SERVICE LETTER 279

13000 Bow Tie Bolt Replacement

Aircraft Makes/Model(s):	Float Model(s):	Compliance: Optional	By: MAS
DeHavilland DHC-6	13000 Series	Part Number: 1013058 Date: 1/26/2026	Approved:DRH Revision: A

Figure 1 – Fitting Location

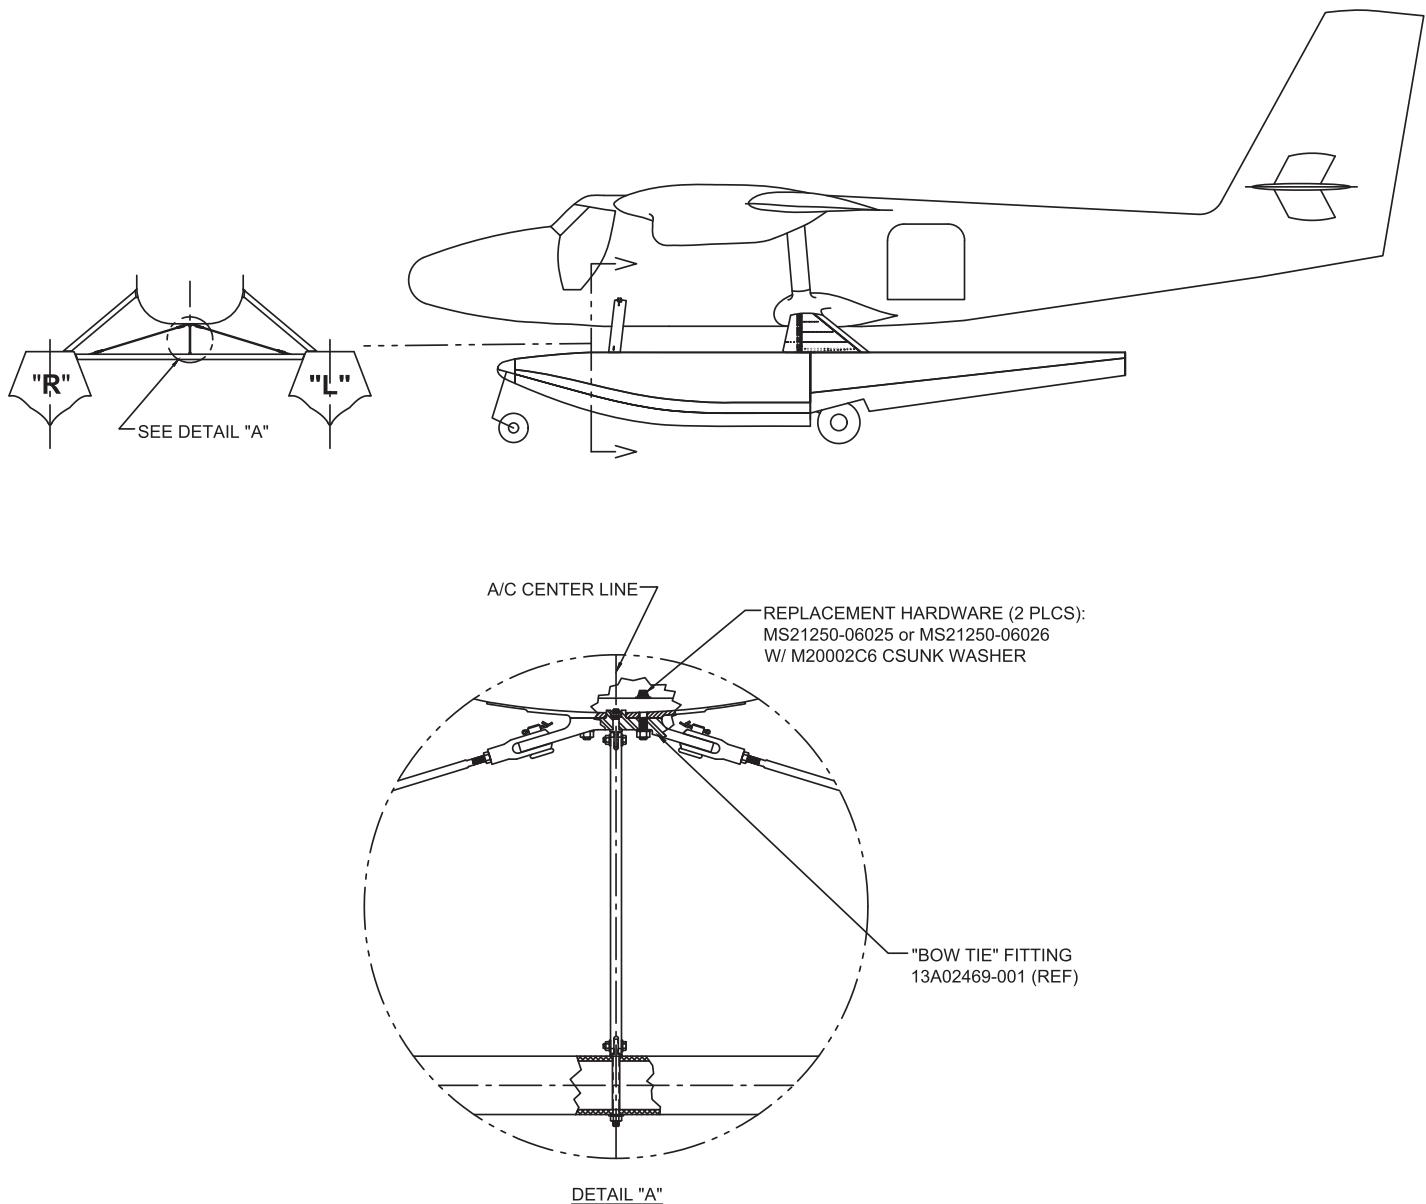
Bolts fastening the upper front drag wire fitting 13A02469-001 – the “bow tie” – have been found sheared, particularly on aircraft that spend prolonged time docked in rough waters. This bolt has since been updated to one of higher strength and with an increased radius under the head.

Replace 2 each bolts per aircraft as needed. Replacement bolt part number to be MS21250-06025 or MS21250-06026, depending on length required. Ensure countersunk washer MS20002C6 is installed under bolt heads. Refer also to install drawing 7D1-3008, Wipaire parts manual 1001021, and Wipaire service manual 1002548.
